## FIELD NOTES

PROJECT: Rockwood 10

SUBJECT: Existing Tree Area – Arborist Walk

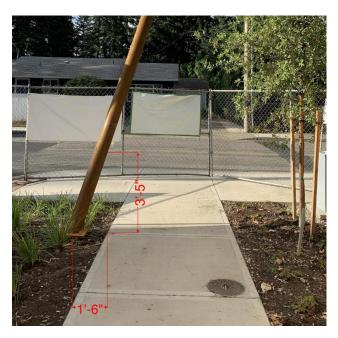
vi. Additional fill (greater than 4" is acceptable in SW Picnic Table area as there are no roots in this area. Refer to Arborist comments.

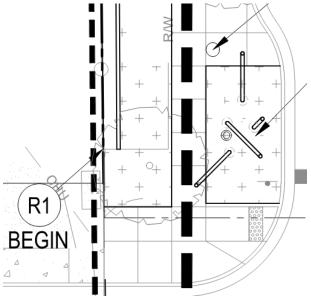
- vii. Install temporary irrigation through out NW Shadow Mix seeded area. Remove once planting is established.
- b. Remove downed tree stump near community building.
